REPORTS OF
CONSULTING BOARD
ON
LAKE HODGES DAM
SAN DIEGO COUNTY, CALIFORNIA

Report to State Engineer

on Lake Hodges Dam

March 11, 1929.

DIAGRAM OF BUTTERRESS LAKE HOGGS DAM
SAN DIEGO COUNTY, CALIFORNIA
To accompany copy of
Henry D. Howell Consulting Engineer
dated March 12, 1928

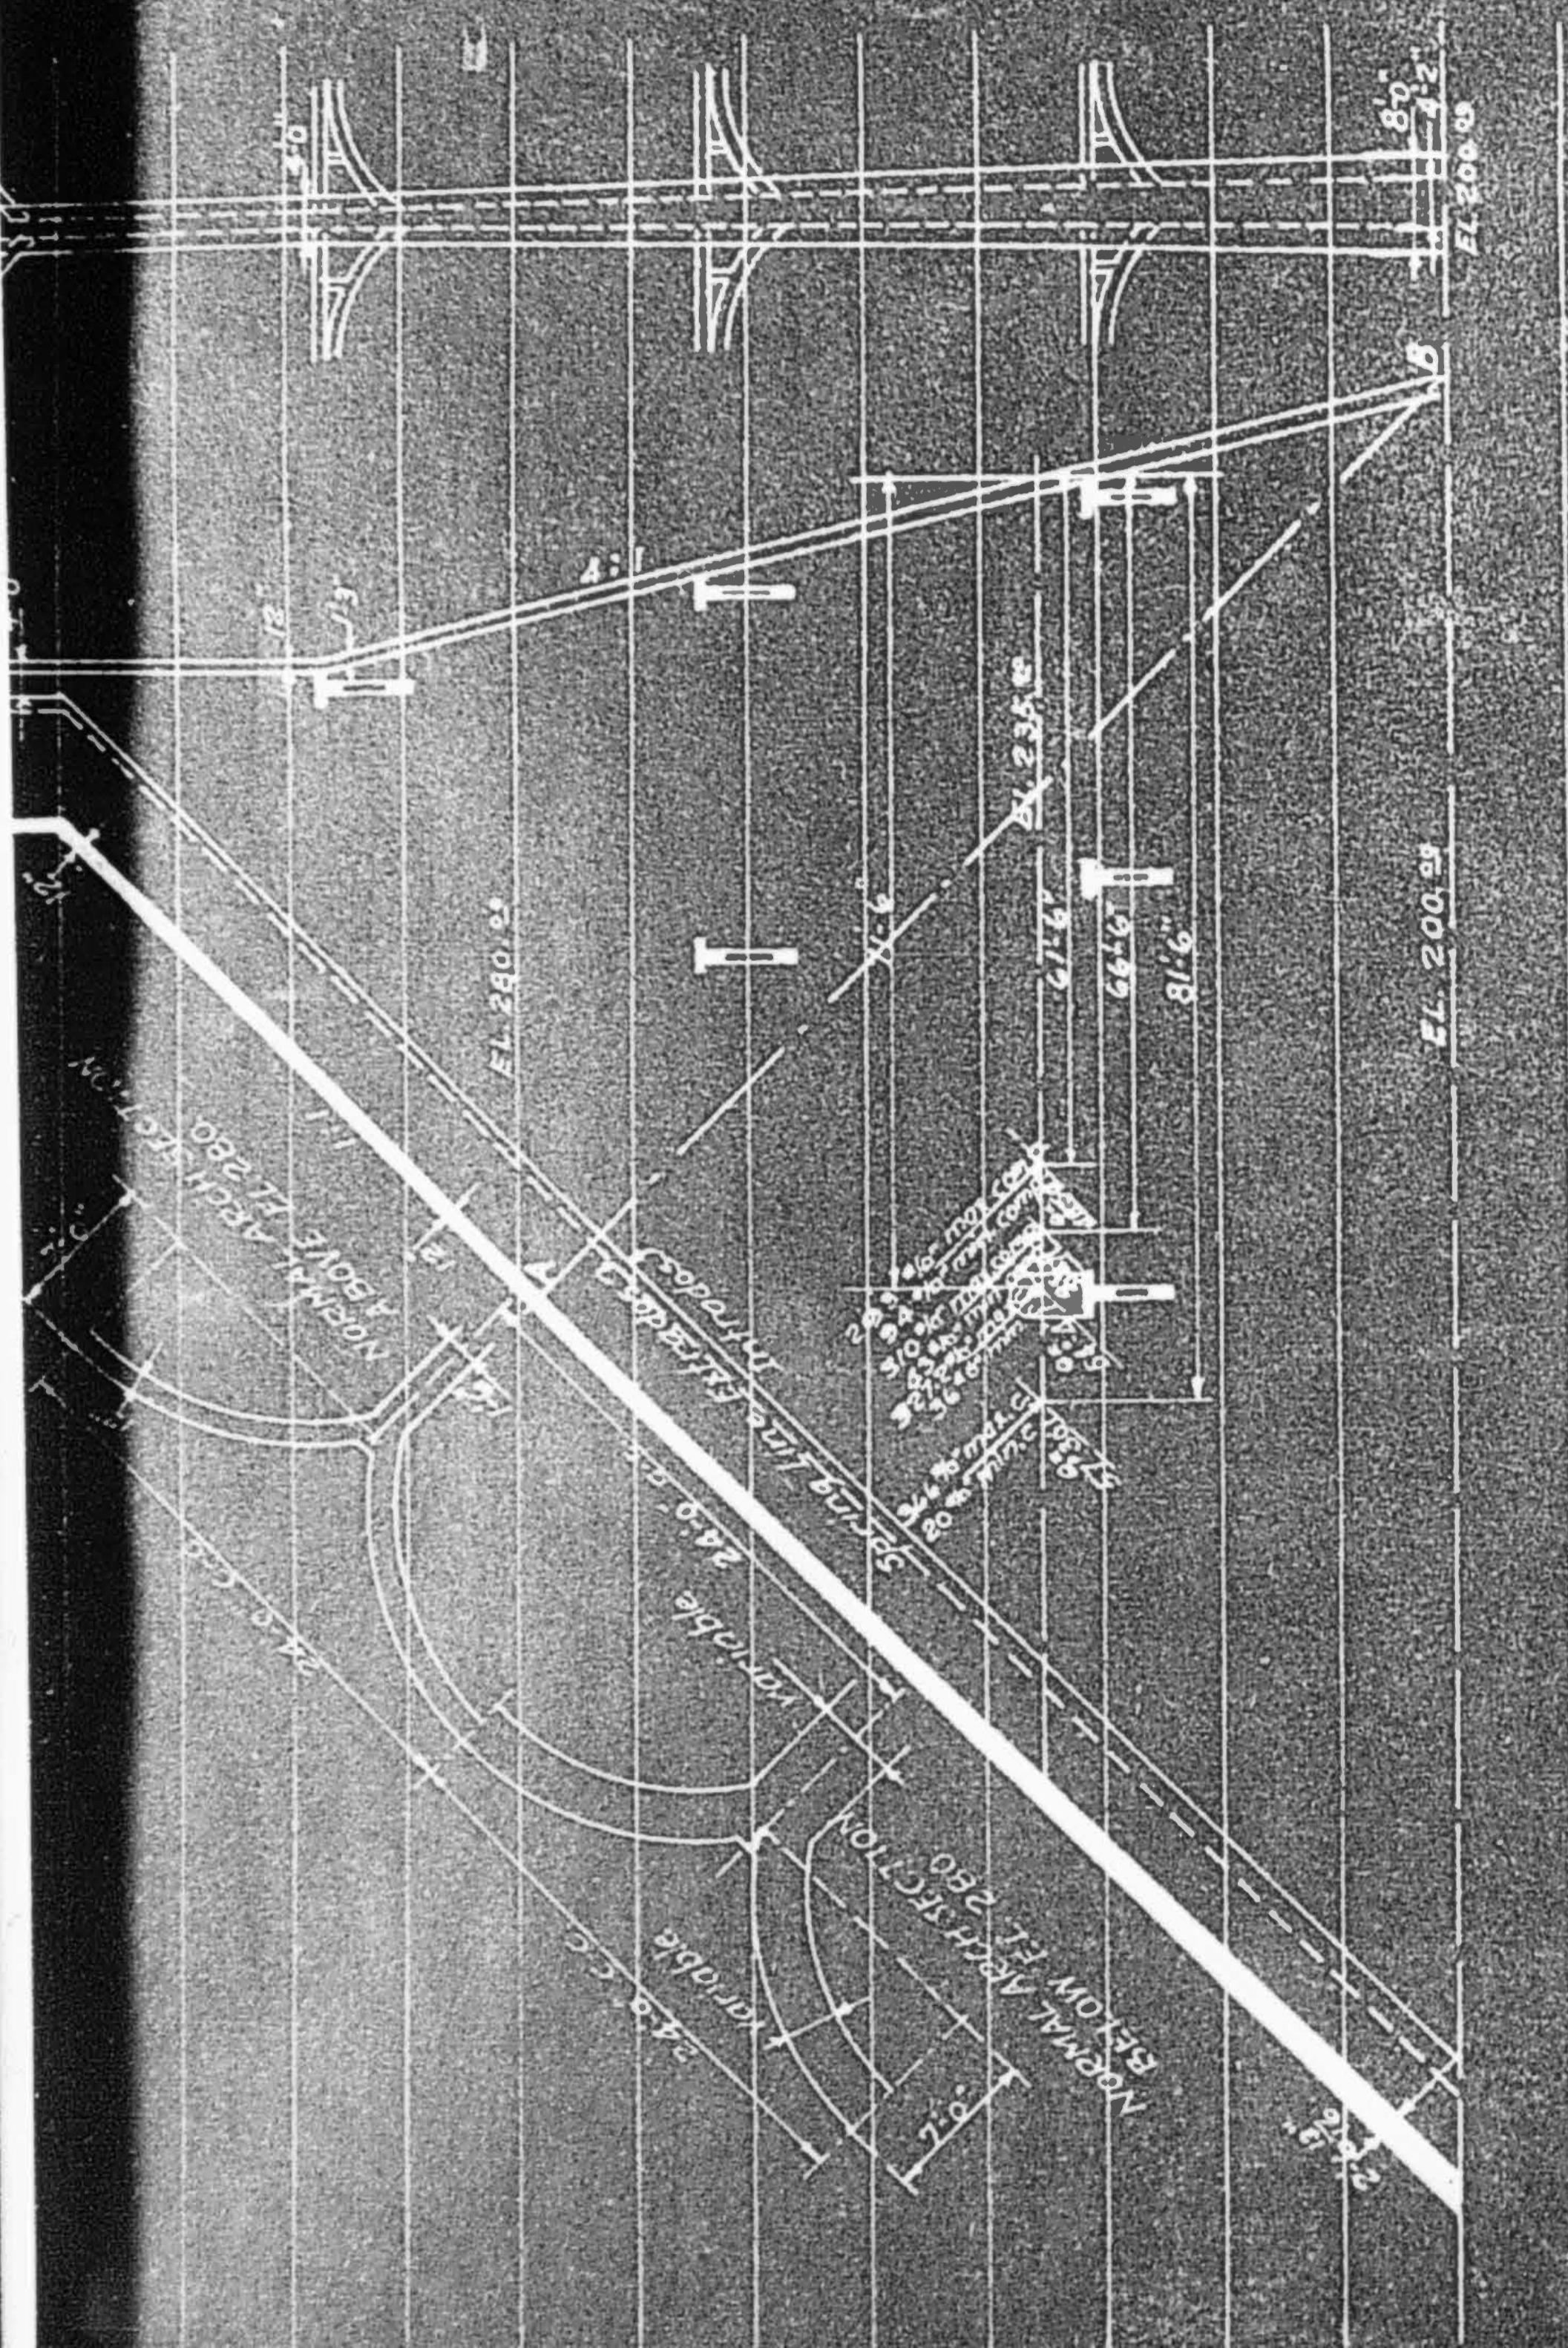
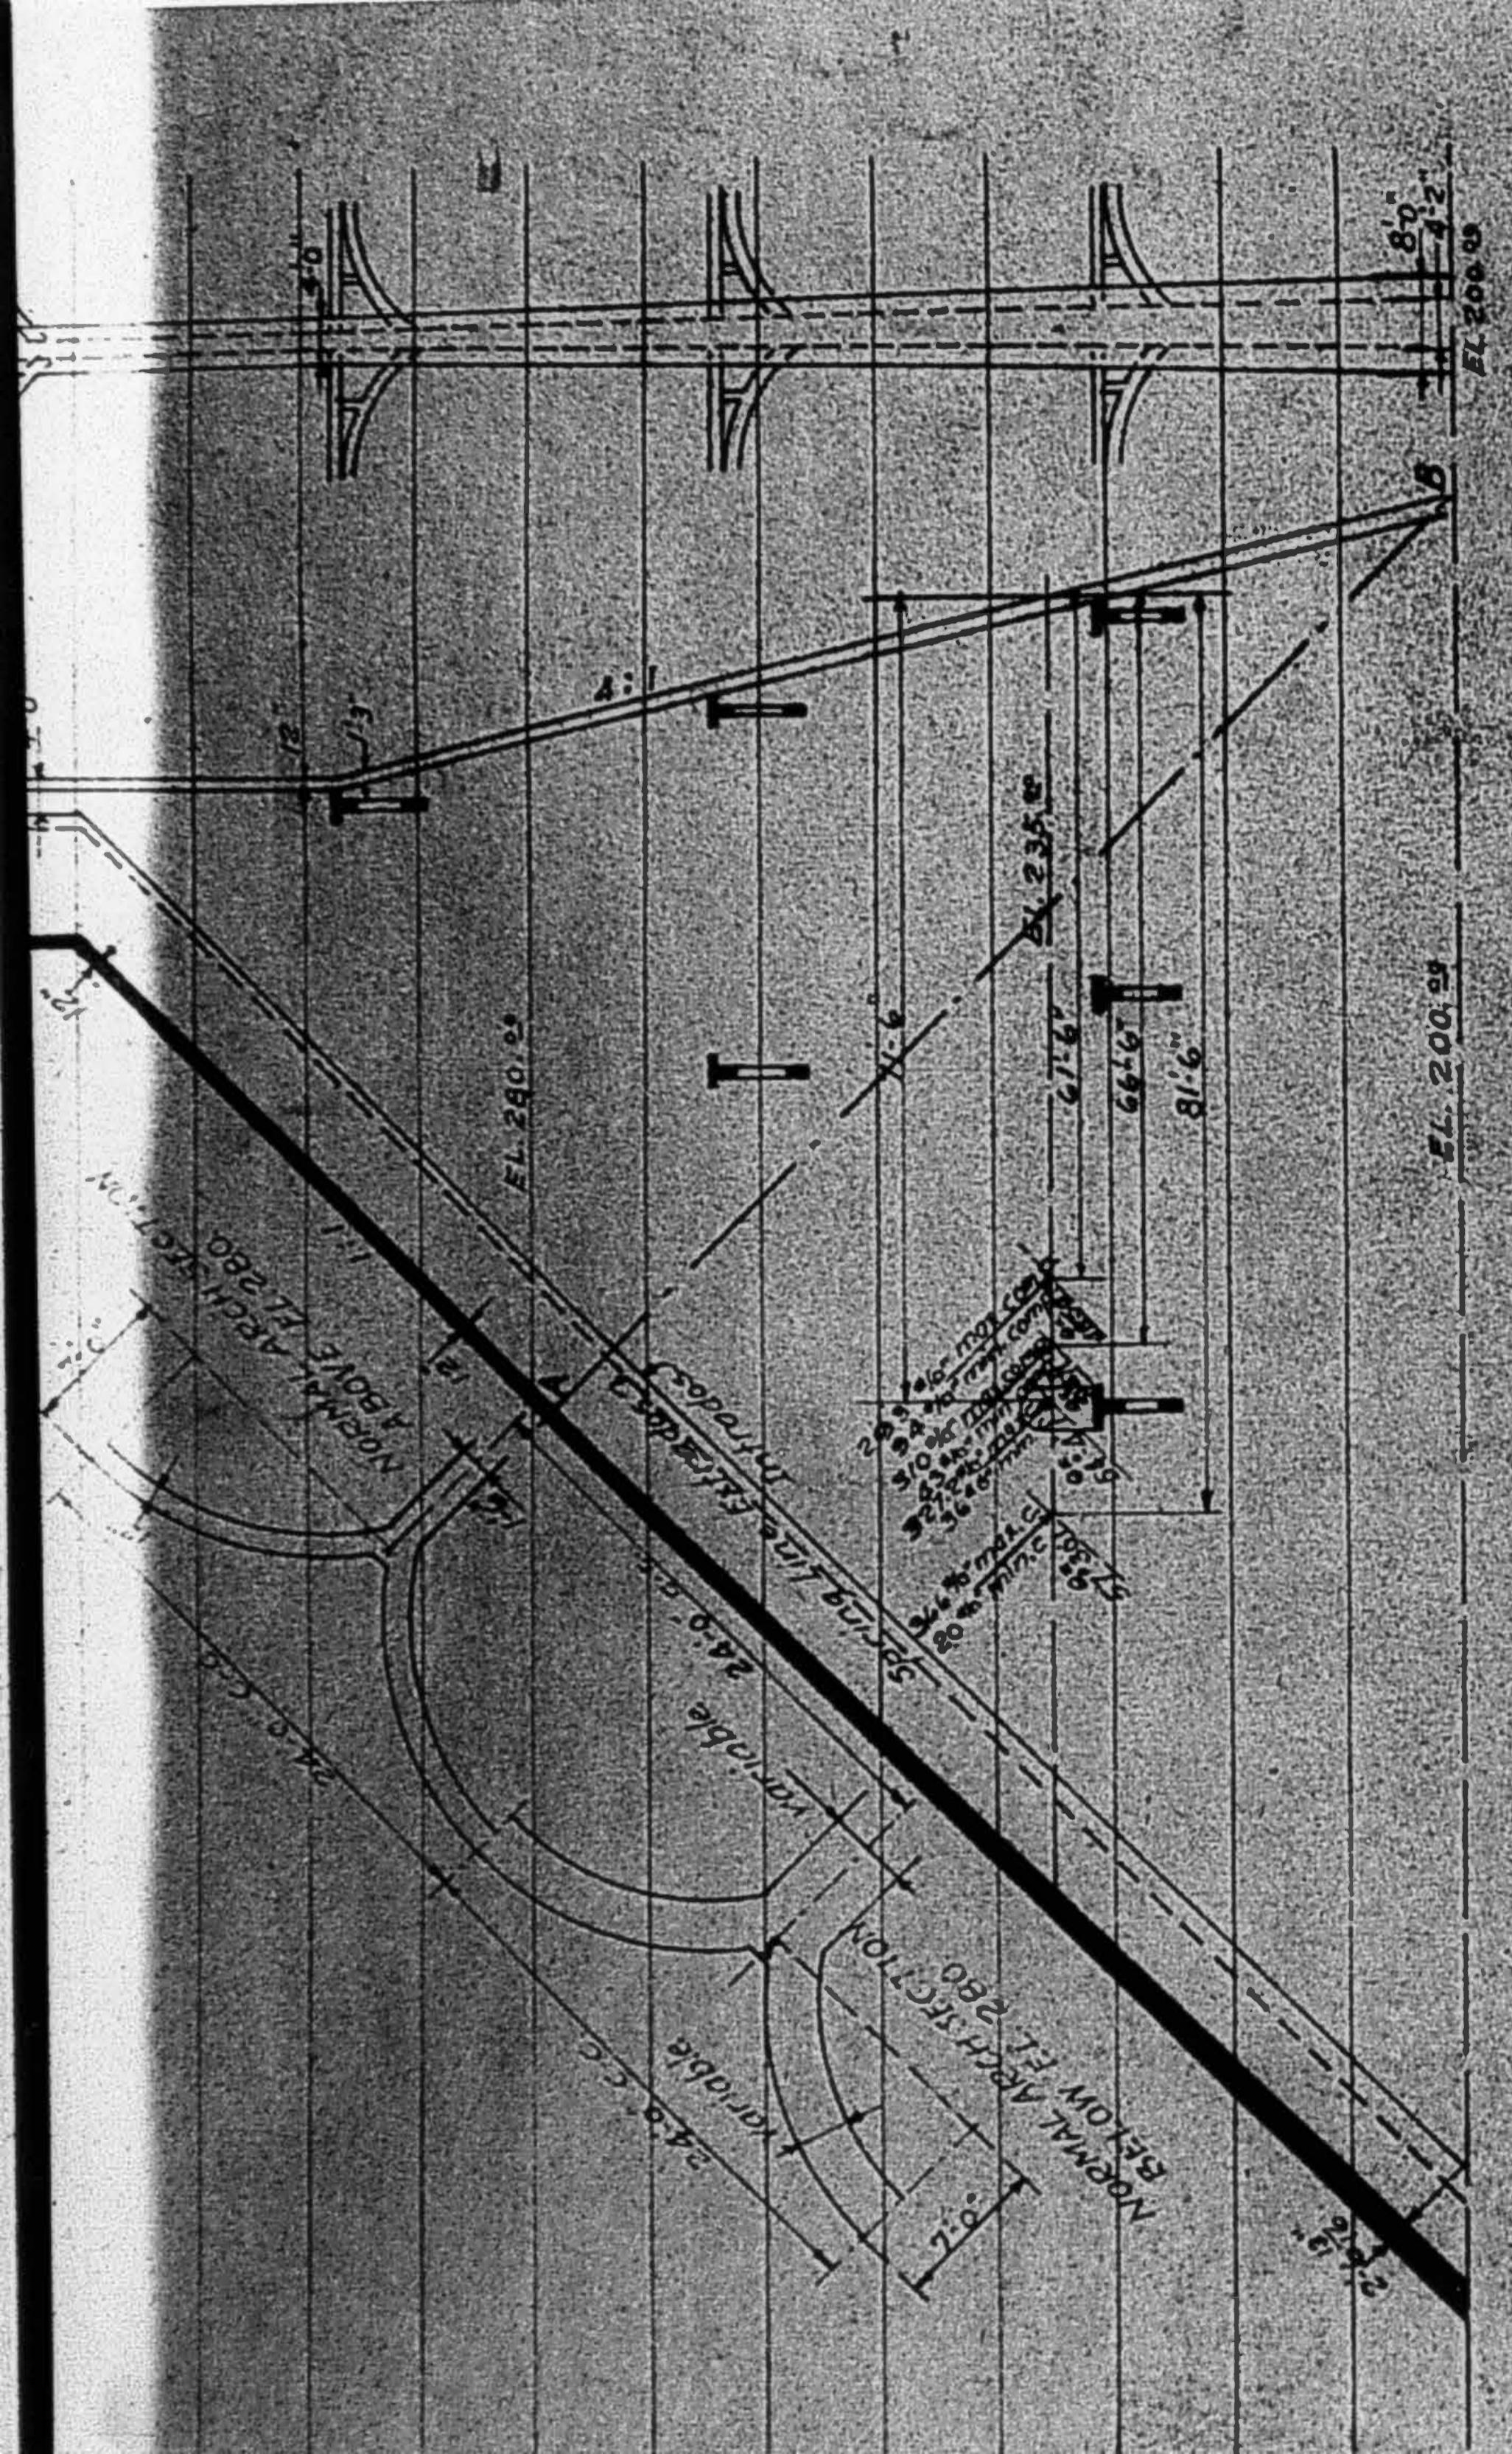
The application of this method to the buttress of a multiple arch dam involves some difficulties. Certain assumptions, additional to those given above, must be made. Nevertheless, I have employed this method to a buttress of the Lake Hodges Dam, and have calculated thereby the principal and conjugate stresses at four points on a horizontal plane through the gallery opening, or at Elevation 235.

These four points, and the stresses found, are shown on Figure 1. The four points are at distances 61' - 6", 66'-6", 71'-6" and 81'-6", respectively, from the back face of the dam. The point which is 71'-6" from the back face is at the center of the gallery opening. Table V, below gives the results of these computations.

These results indicate that, for the uncracked buttress, there is no tension across an inclined plane following the present crack. Certain points, which may have some significance, are to be noted from the figures of Table V.

(1) The plane on which the minimum compressive stress acts has the same direction as the present crack.
